Application for Licence Amendment

Licence Number	L8550/2011/1
Licence Holder	B & J Catalano Pty Ltd
ACN	008961975
File Number	APP-0026711
Premises	Martin Road Gravel Quarry Martin Road MORNINGTON WA 6221 Legal description: Lot 202 on Plan 63120 and part of Lot 104 on Diagram 85224
Date of Report	23 July 2025
Decision	Revised licence granted

Figure 1. Lot 202 initial extraction area and respective stormwater ponds included in the licence amendment granted in 2021

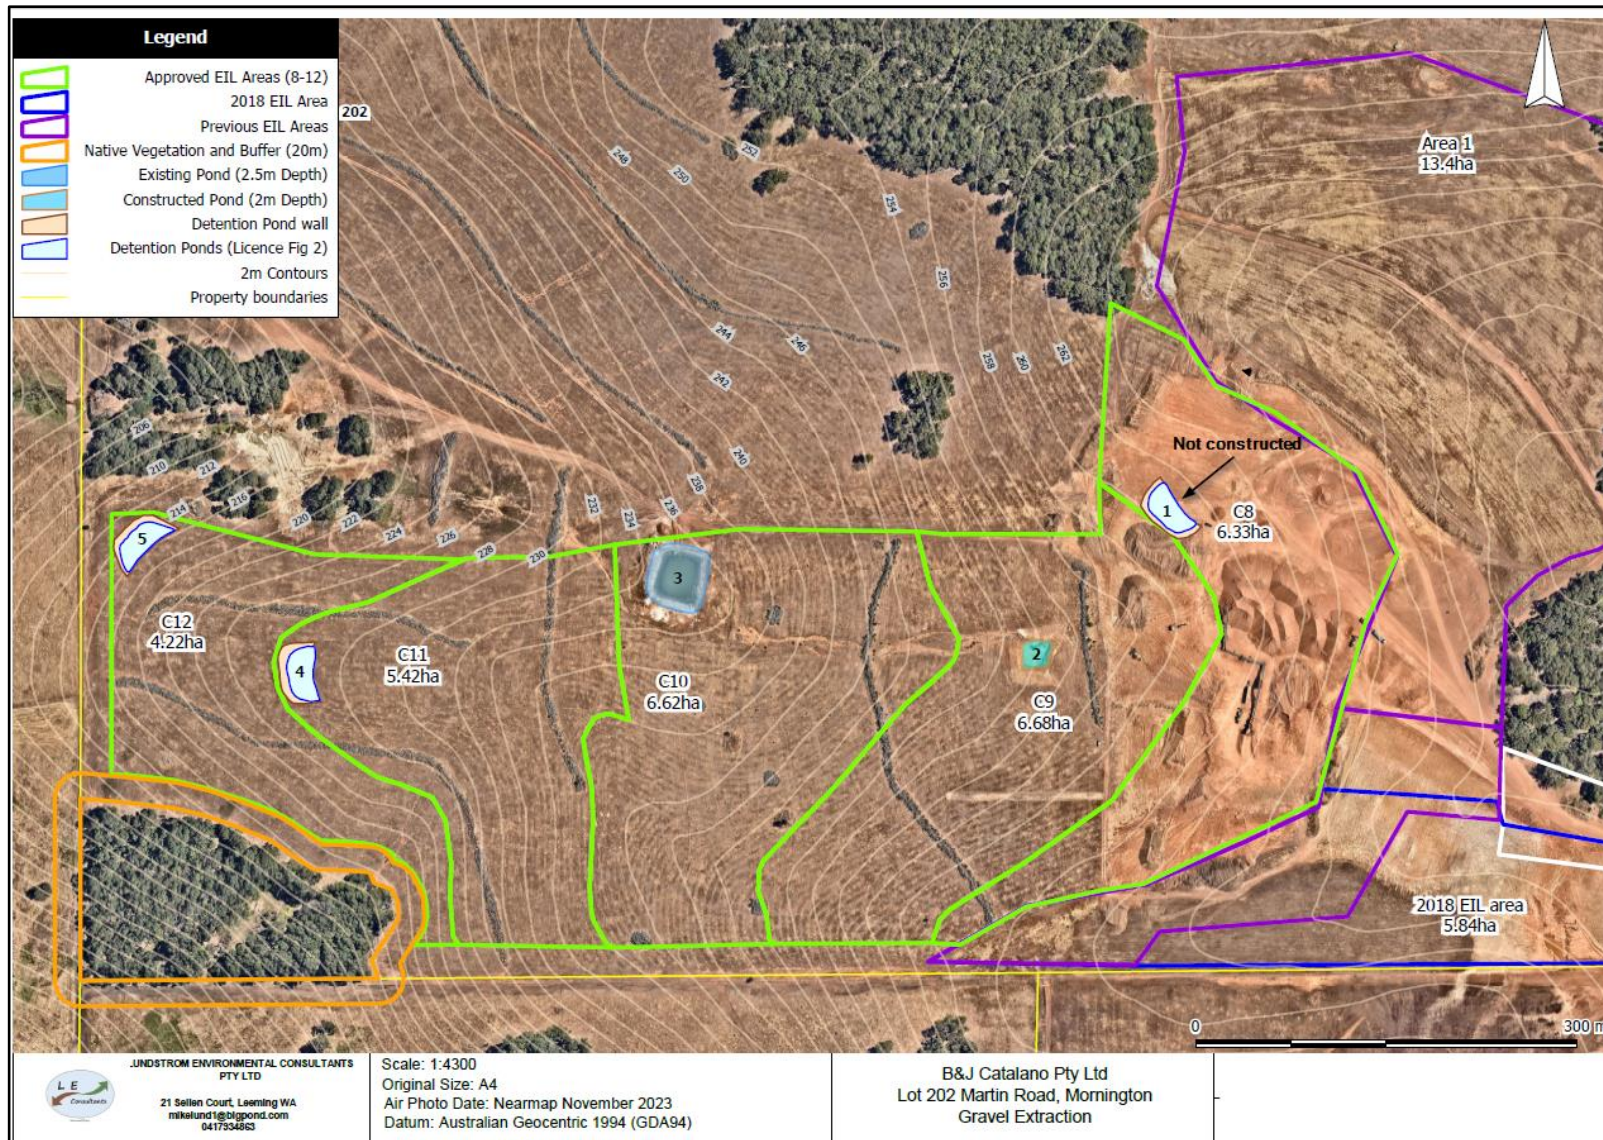
A construction compliance report submitted in 2023, intended to demonstrate adherence to the licence construction conditions for stormwater pond 1 and 2, indicated that while stormwater pond 2 (area 9) was compliant with the conditions of the licence, stormwater pond 1 (located in area 8, to the east of lot 202) had not been constructed. The departure from the conditions of the licence was due to the pit floor being lower than the surrounding terrain following extraction. The resulting depression naturally collected stormwater, effectively serving as an alternative stormwater management solution.

Furthermore, calculations undertaken by the licence holder showed that the combined stormwater capacity of the already constructed ponds 2 and 3 (in area 9 and 10 of Figure 1) far exceeded the predicted runoff volume from the activities across stages 8-10, estimated at approximately 6,000 cubic meters.

During the assessment of this amendment application the department noted that aerial view of the premises from September 2024 indicated that only pond 3 in area 10 had been retained. Pond 2 was no longer at the premises and areas 8 to 10 had been mined seemingly with only one stormwater pond (3) remaining. Additionally, topsoil stockpiles intended to redirect uncontaminated stormwater away from the processing area were not located where initially proposed.

- stormwater ponds in areas 8, 9 were never constructed, contradicting information submitted in the construction compliance report for stormwater pond 2 in 2023. Windrowed stumps from felled blue gum trees were placed along the contours to redirect

contaminated stormwater to pond 3 instead.

Figure 2. Proposed operations expansion area and location of stormwater management infrastructure

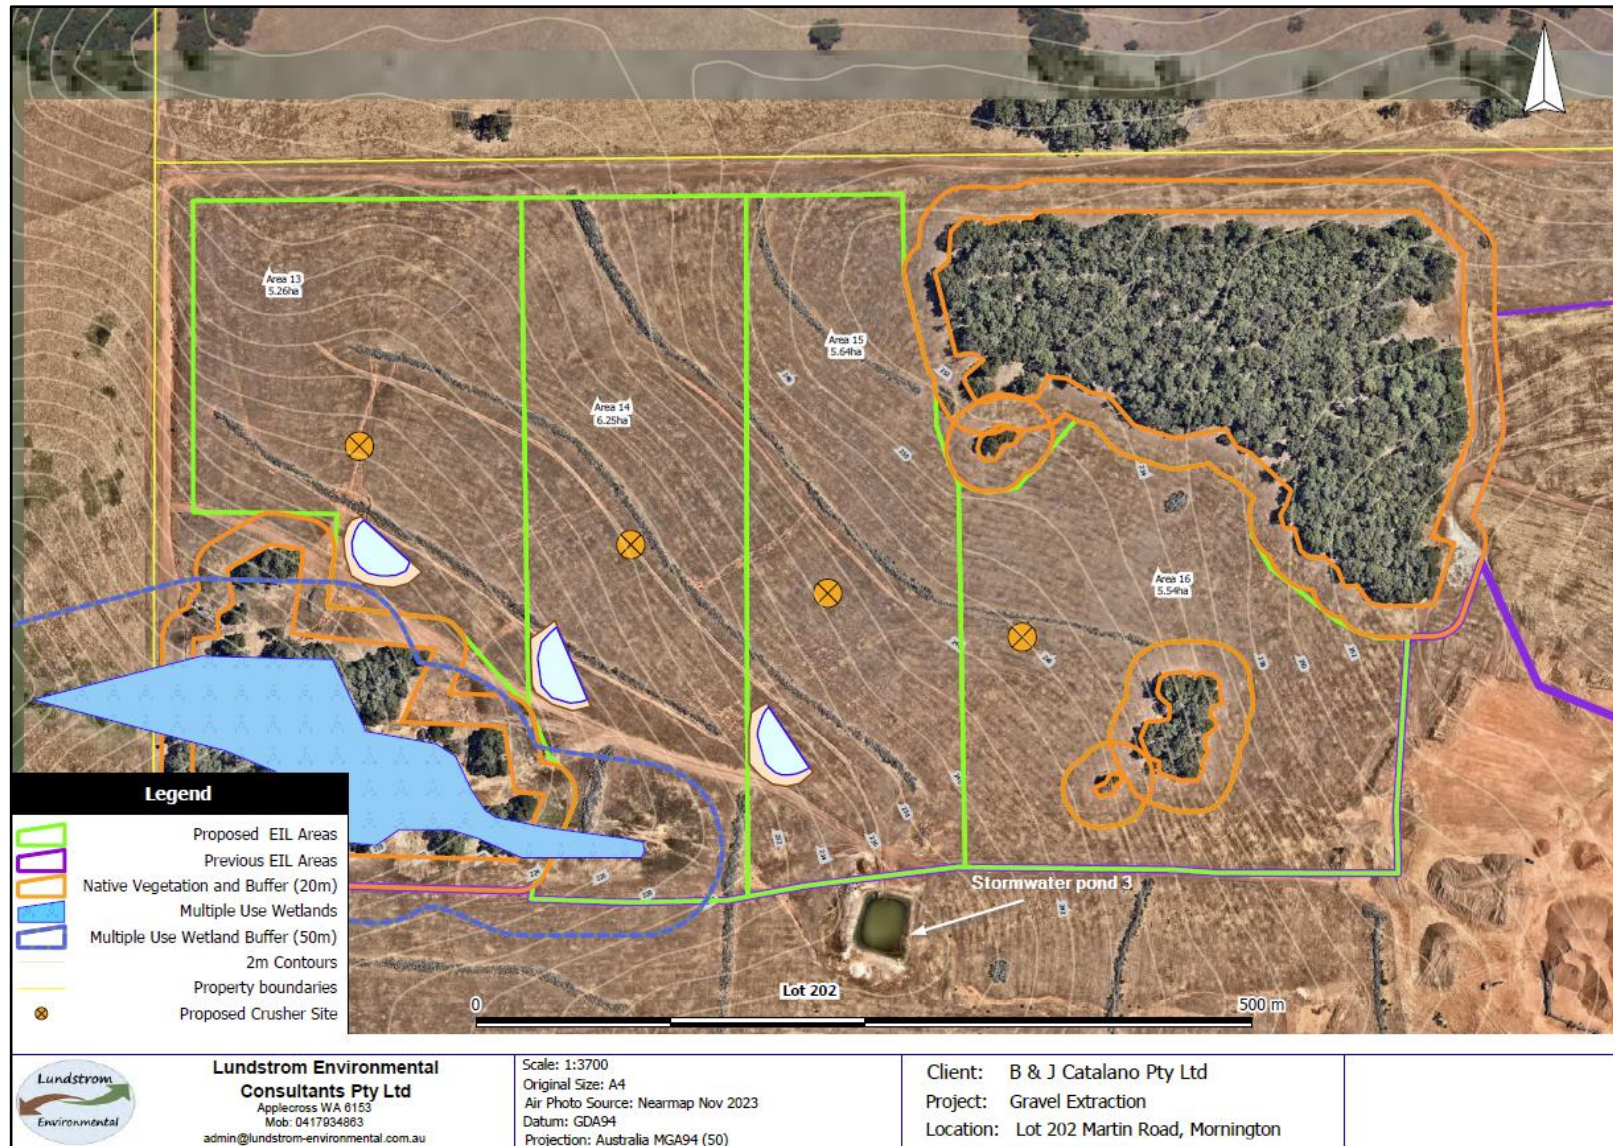
Three new ponds will be constructed in areas 13, 14, and 15 to collect any contaminated stormwater generated during activities. In the easternmost campaign (area 16), stormwater will be directed to an existing pond (3) to the south of area 15 (Figure 2). Stormwater will be directed into the ponds via contour banks spaced approximately 45 metres apart, with an average gradient of 0.2% (Figure 3). The capacity of the stormwater ponds was calculated using the rational method for peak runoff of a two-hour rainfall event with a 10% annual exceedance probability (AEP). Approximate pond capacities are shown in Table 1. Each pond will be excavated to a depth of approximately 2 metres below ground level.

Proposed activities show that a 50 metres buffer from any surface water source will not be maintained during the campaign in extraction area 14, as the area overlaps the northern part of the multiple use wetland.

- freeboard allowance for the stormwater ponds to manage the risk of overtopping
- how the freeboard allowance would change the proposed capacity of each of the ponds
- to provide a figure with the approximate locations of the topsoil and gravel stockpiles for the purpose of limiting emissions (the Delegated Officer notes that this was provided during the 2021 amendment application)
- to provide a figure showing the management of stormwater from area 16 into the existing pond (3).

While the response submitted on 9 May 2025 provided some updates on ongoing operations, it did not address any of the above questions. Furthermore, the licence holder indicated that as no ponds were constructed for the previously assessed areas 8-12, no freeboard was reportable to date.
